City of Portland, Maine - Building or Use Permit Application 389 Congress Street, 04101, Tel: (207) 874-8703, FAX: 874-8716

REASON FOR PERMIT: To Construct 14' x 16' addition.

ROB DUCLOS
- 14' X 16' ENTRY
- FRAMING DETAIL

CHECK-LIST AGAINST ZONING ORDINANCE

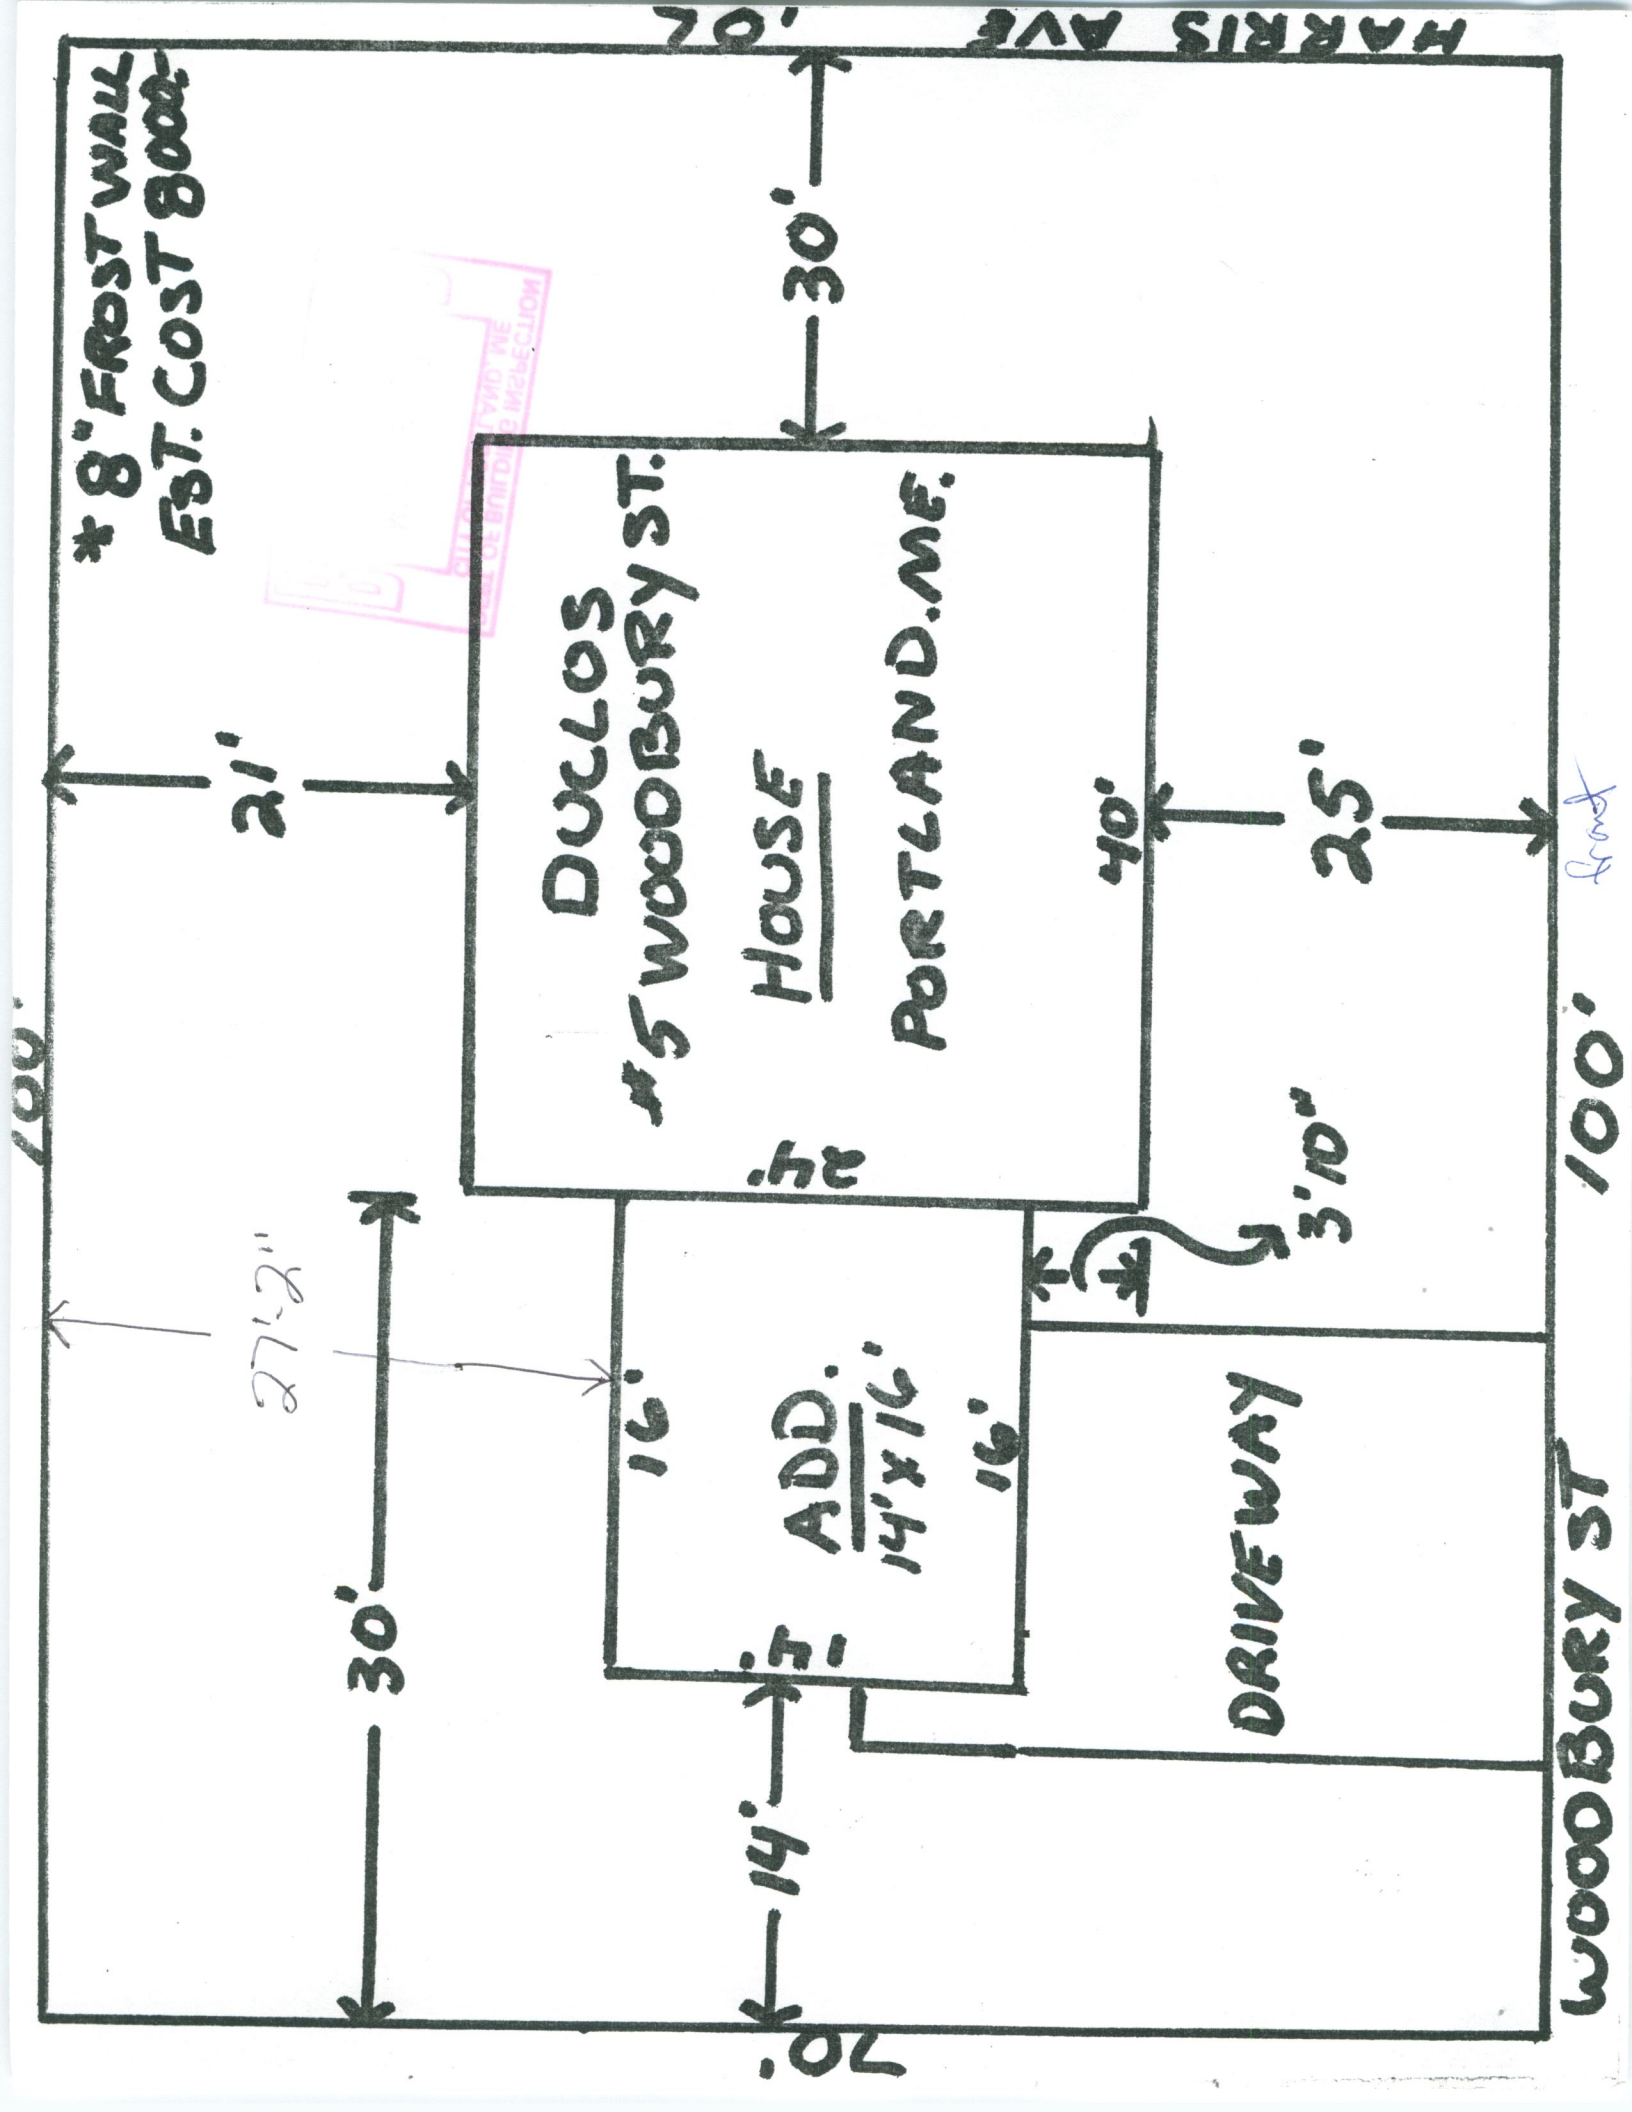
Side Yard - 8' req - 14' shown

Lot Coverage/ Impervious Surface - 25% MAX coverage or 1750[#] MAX

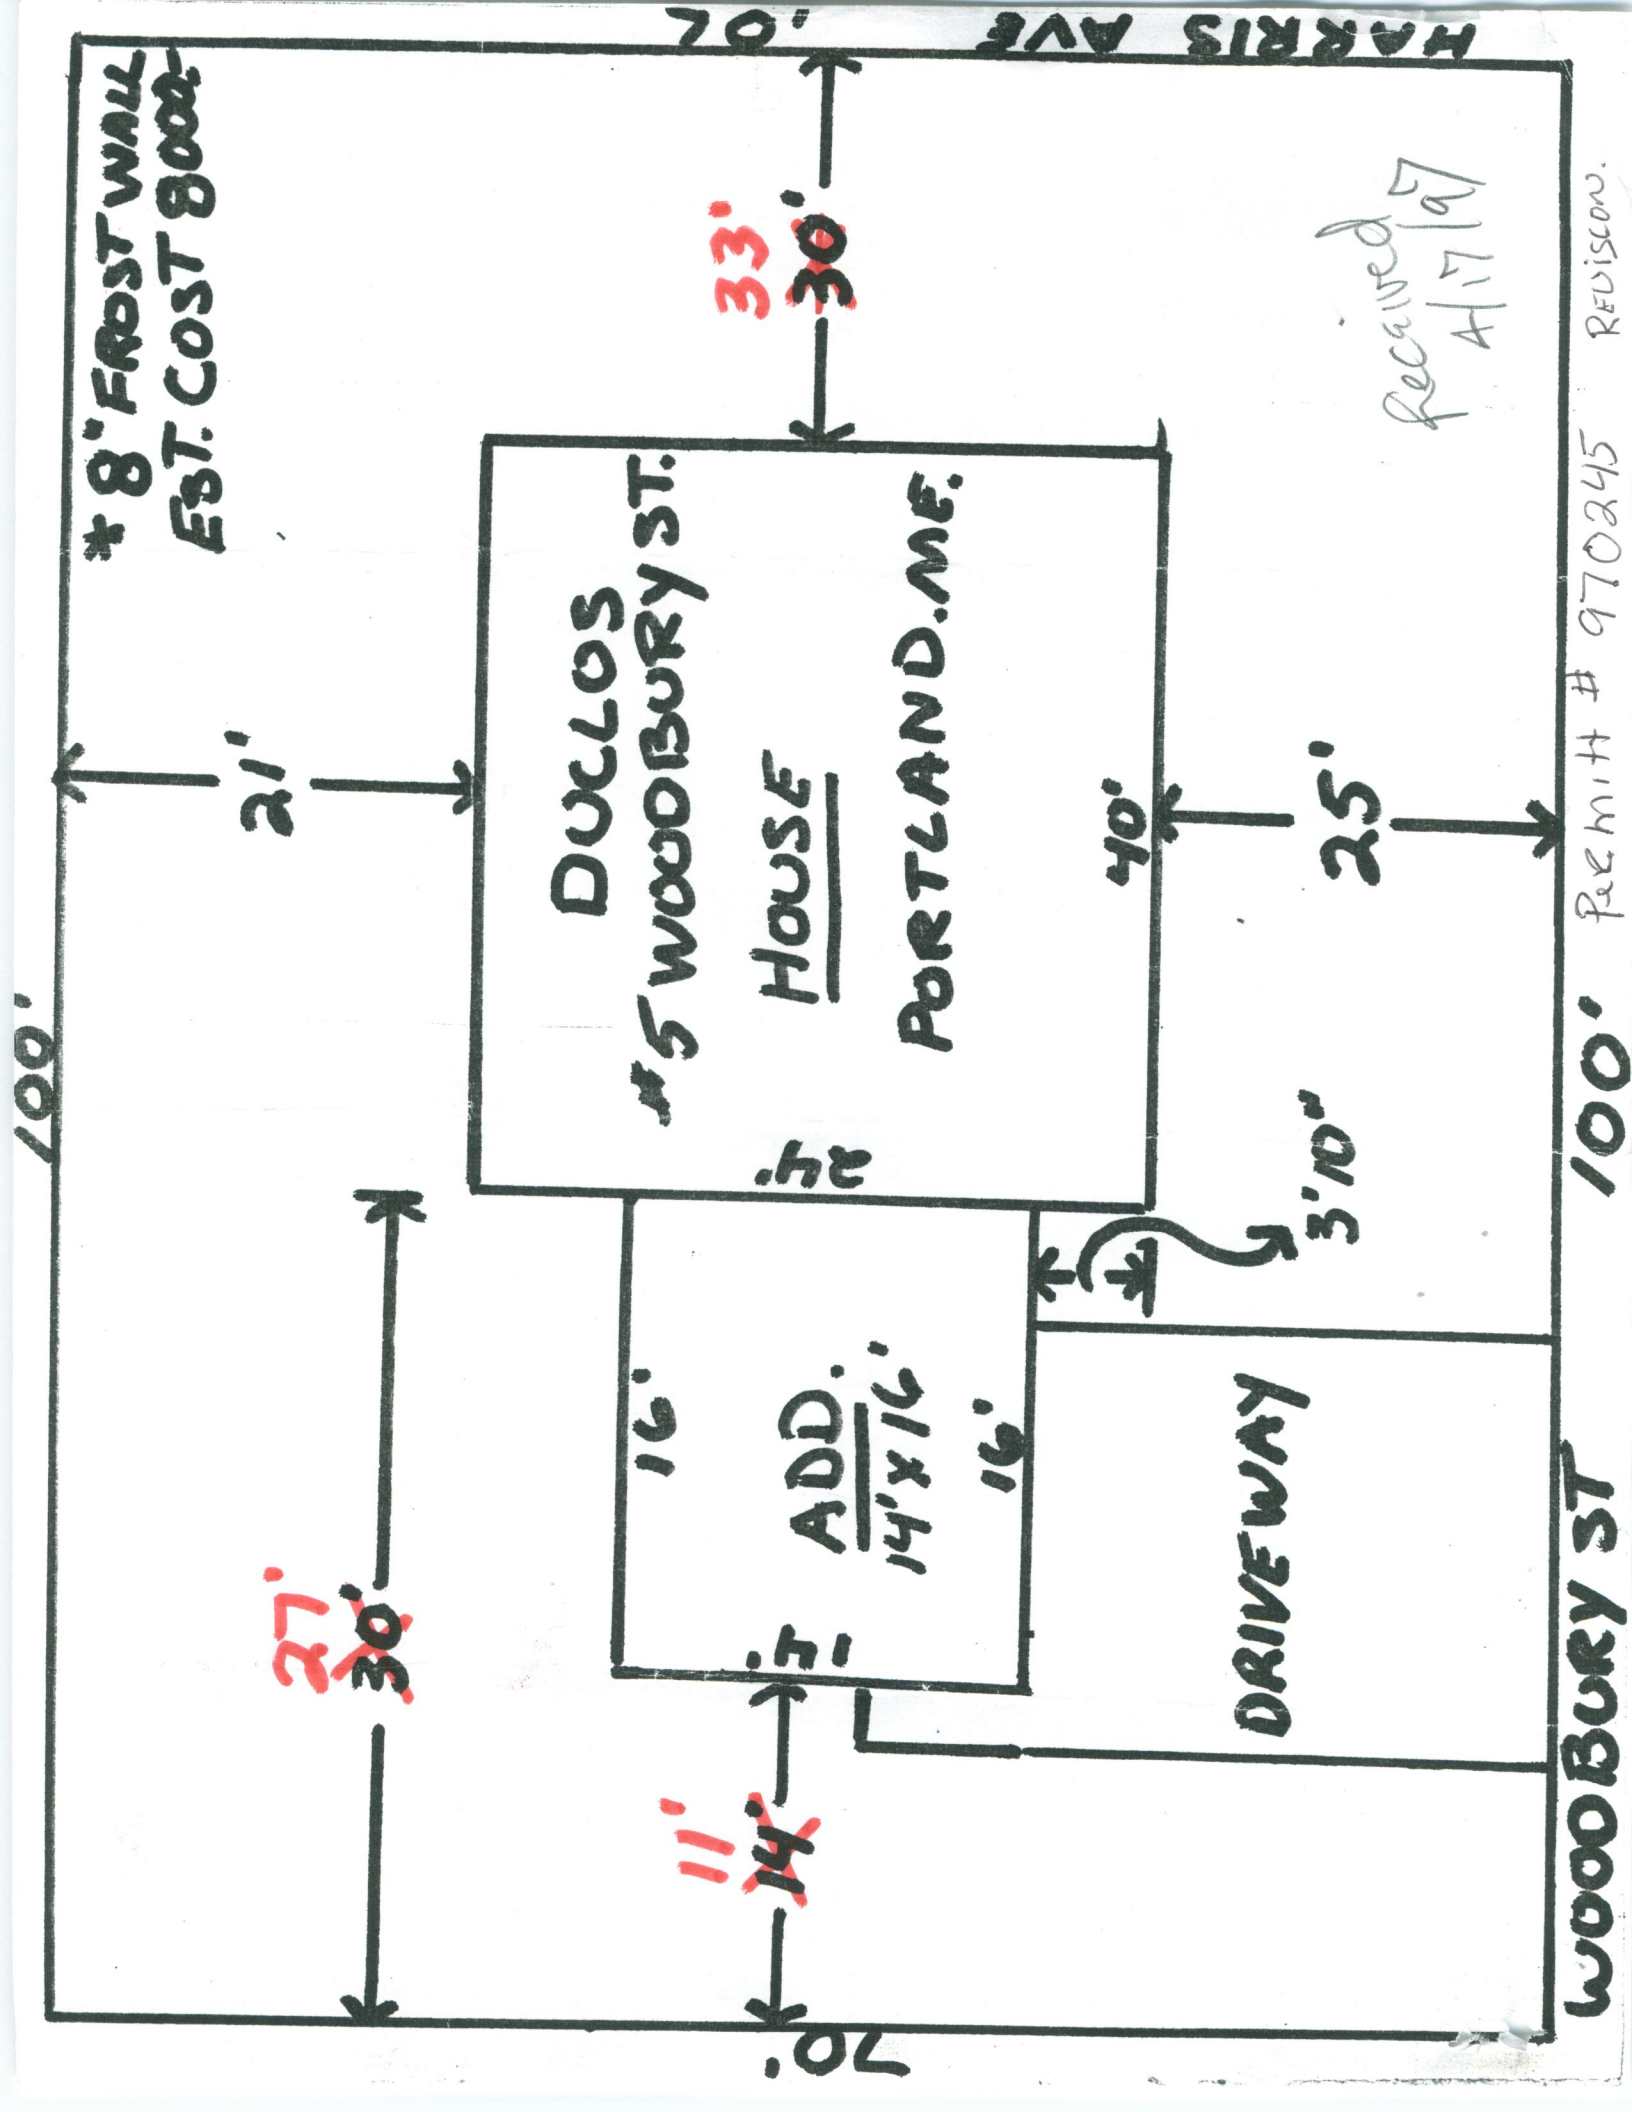
advised owner that he should consider perimeter drains - heavy clay soil @
